GREENLANDS NATIONAL GALLERY OF ART
GRØNLANDS NATIONALGALLERI FOR KUNST

INVITED DESIGN COMPETITION
INDBUDT PROJEKTKONKURRENCE

JURY REPORT FEBRUARY 2011
DOMMERBETÆNKNING FEBRUAR 2011

28 | GREENLANDS NATIONAL GALLERY OF ART ENTRY 3 HEIKKINEN-KOMONEN ARCHITECTS

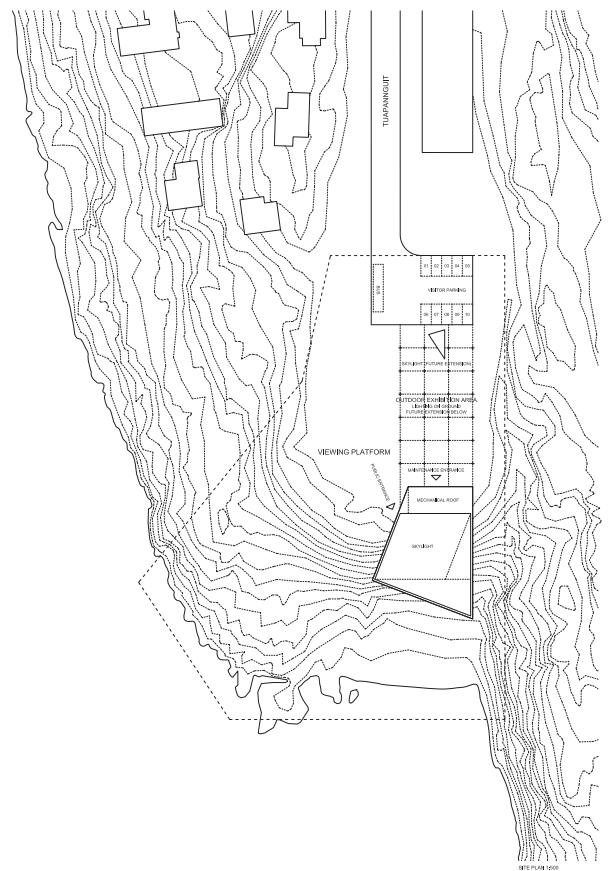
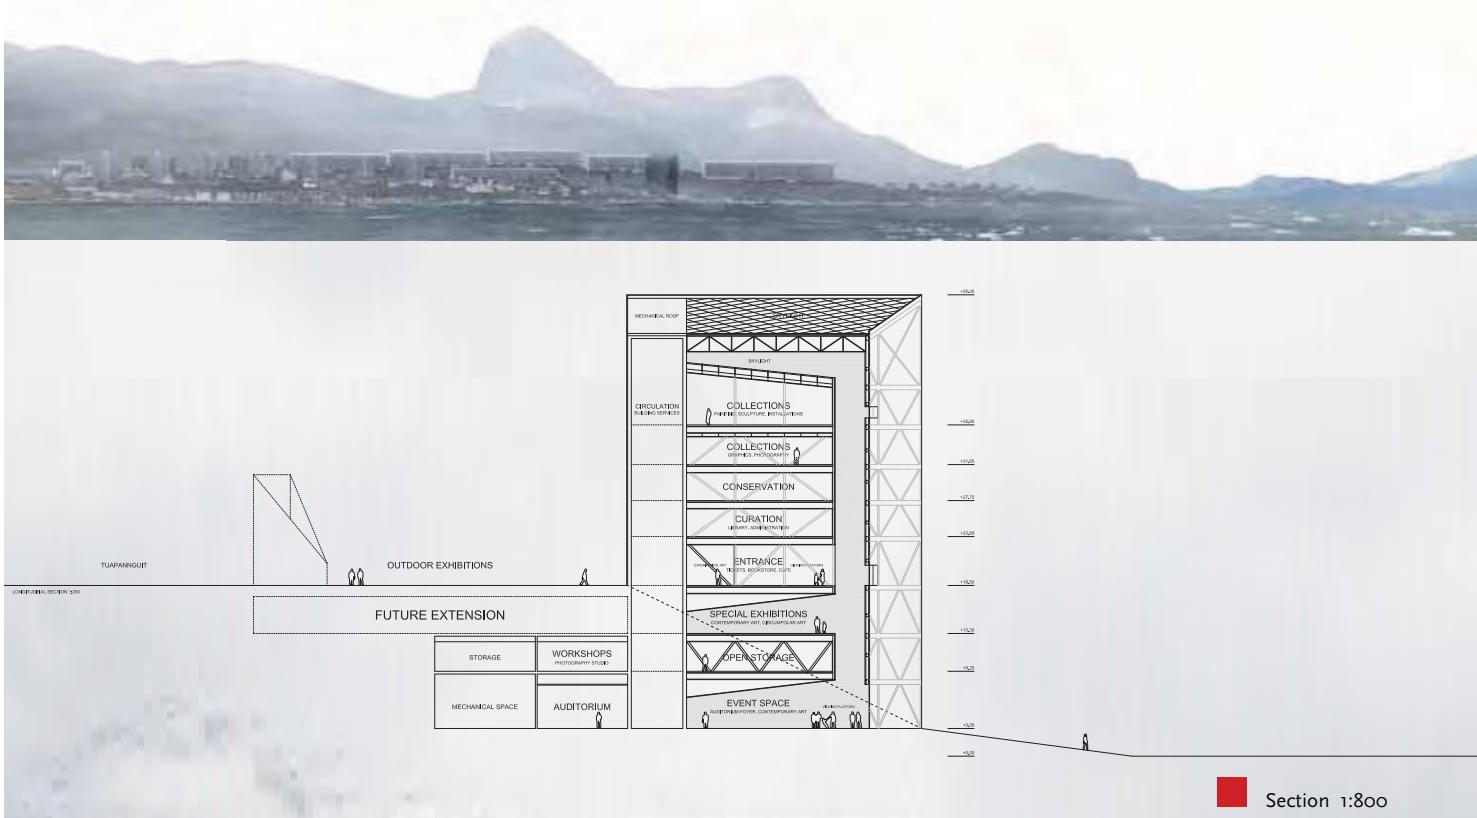
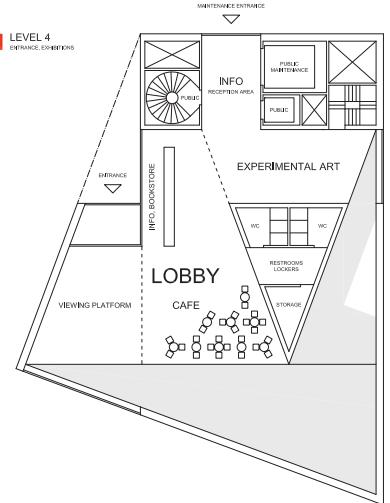
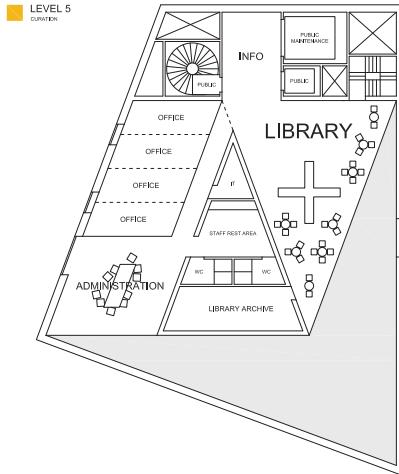
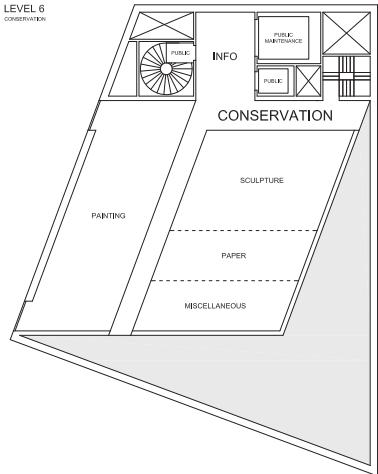
The Jury was taken with the idea of establishing a powerful monument to Art on this site, but the layout over several storeys, and not least the confined access via stairs and lifts, render this an inappropriate design which does not offer the qualities in terms of experience which are required by the brief.

The rooflight in the uppermost exhibition room is beautifully conceived but the provision of daylight in the other areas is

unsatisfactory. The space running between the outer shell and the suspended floors seems unnecessarily dramatic.

The outlined event space on the bottom level is beyond the remit of the brief and, combined with other allocations of areas, means that the footprint of the building exceeds that provided for in the brief by almost 50%; a commensurate increase in costs is anticipated.

Viewed from the fjord, the proposal is for a building of some 47 m in height, with a core of cast-in-situ reinforced concrete enveloped in a steel lattice structure clad in corroded/weathered steel (corten steel). The vertical load from the wall structures of the storeys does not seem to be thoroughly worked out and is likely to necessitate supplementary vertical structures in the lower storeys. The roof is a steel grillage clad in glass to admit light into the exhibition floors. The foundations of the building are close to the level of the water table, corresponding to the fill depth, but there is no provision for the effects of the rise and fall of the tide (difference of up to 4-5 metres) on the building.

The design of the proposal, providing an air shaft running the full height of the building, does not allow for the problems this entails with the building services. The proposal is not deemed to be able readily to meet the requirement of the competition brief: to achieve a design "of a high technical standard".

JOHAN CELSING ARKITEKTAKTOR

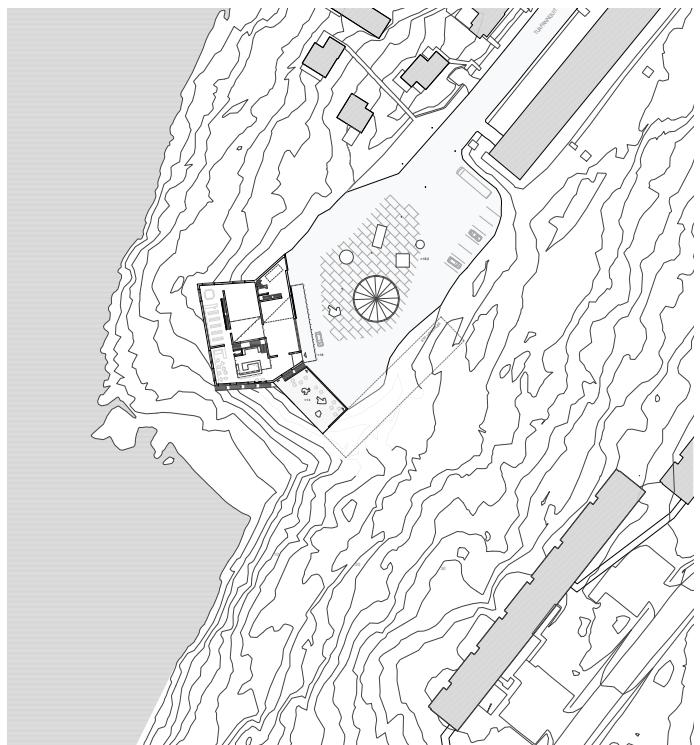
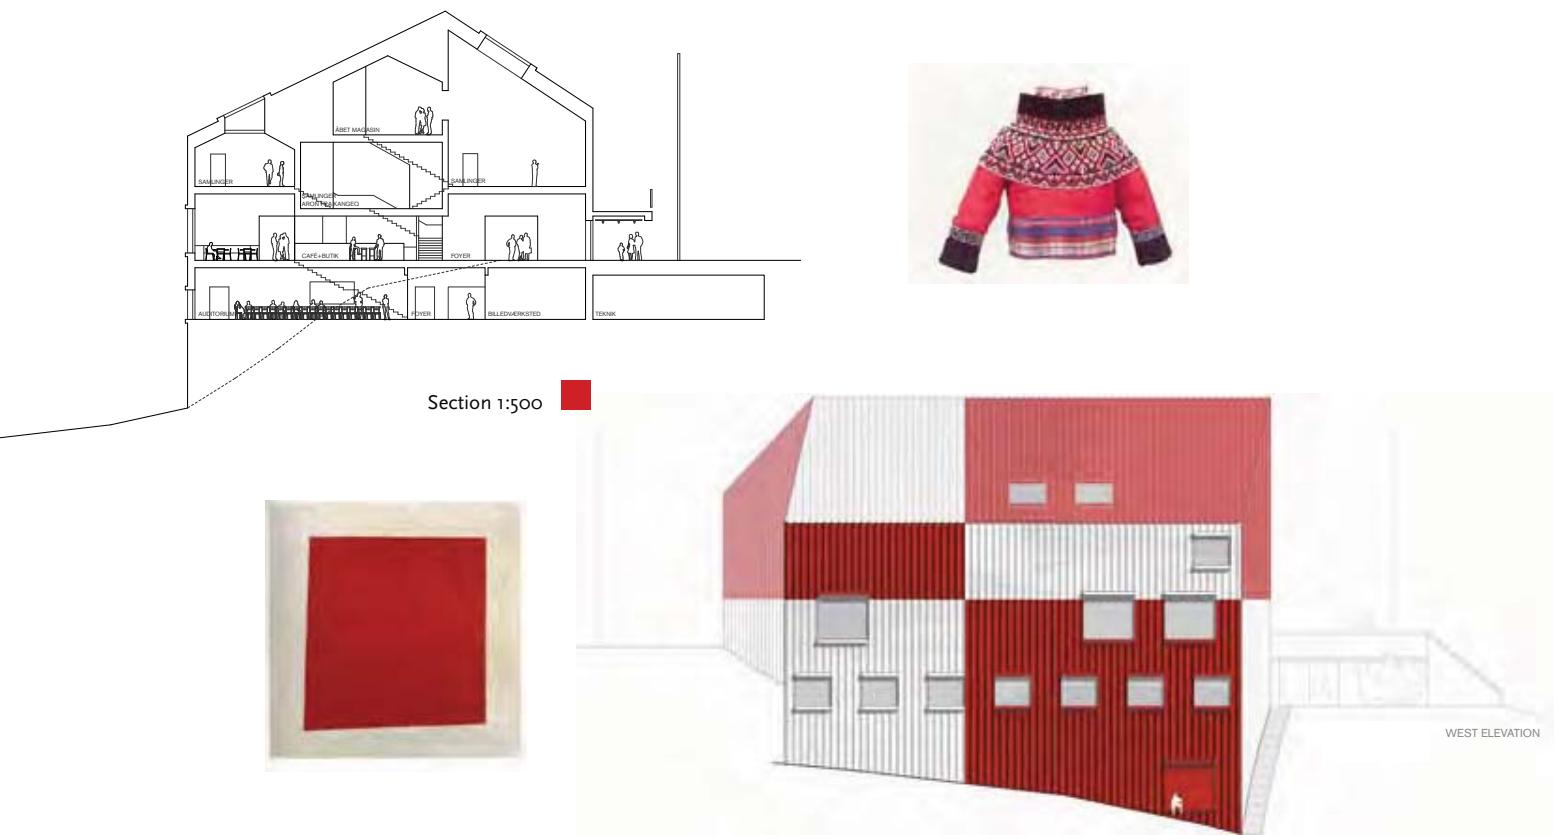
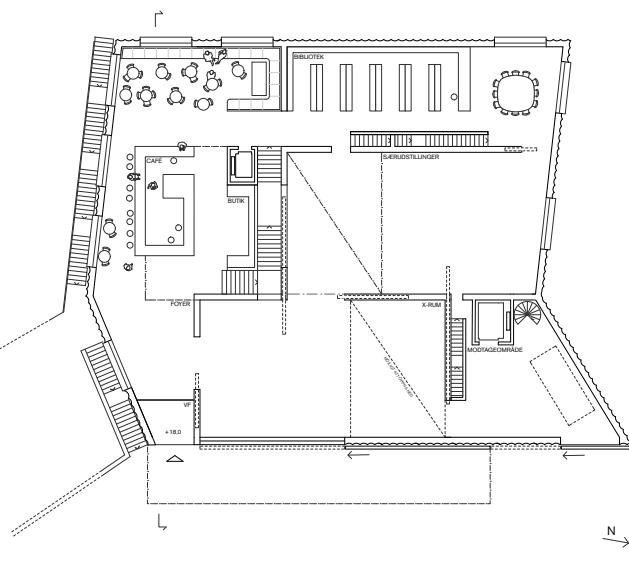
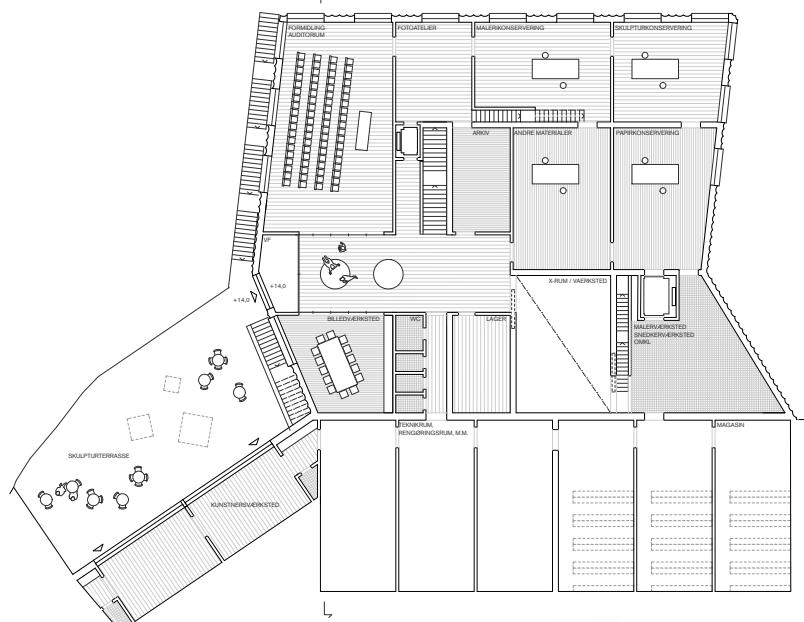
There is no doubt as to what the authors want – but it is important not to forget the objective of the competition: A National Gallery of Art in Nuuk, Greenland's capital city. This proposal lingers on the home and looks to expand on the concept of the home for a solution for this project – which of course is no solution as it is not elevated in higher architectural terms. The ideas are laudable but go no further than a concept for a village hall.

The design deserves praise for its excellent references to craftsmanship, colour studies and graphic outline and for the soft pencil strokes which with playful ease convey a warm, lived-in quality. The proposal's mission and humane scale won the respect of the Jury but its notions for a national gallery were simply unrealistic.

The proposal is described as a cast-in-situ reinforced concrete building. The facades are shown with wave-like vertical contouring, described as being cast on "concave, bowl-shaped moulding benches". It is not deemed to be practicable to craft the facades as shown, as the sharp peaks of the waves could not be kept intact when being struck from the moulds and should therefore have "geometric substance".

It is therefore felt that the overall concept of a cast-in-situ concrete building is not viable and that the building should more accurately be defined as a concrete element building. Painted concrete surfaces on a building in this location which is so exposed to the elements are not judged to be appropriate.

Moreover, the proposal does not include technical engineering specifications and is not deemed to be able readily to meet the requirement of the competition brief to achieve a design "of a high technical standard".
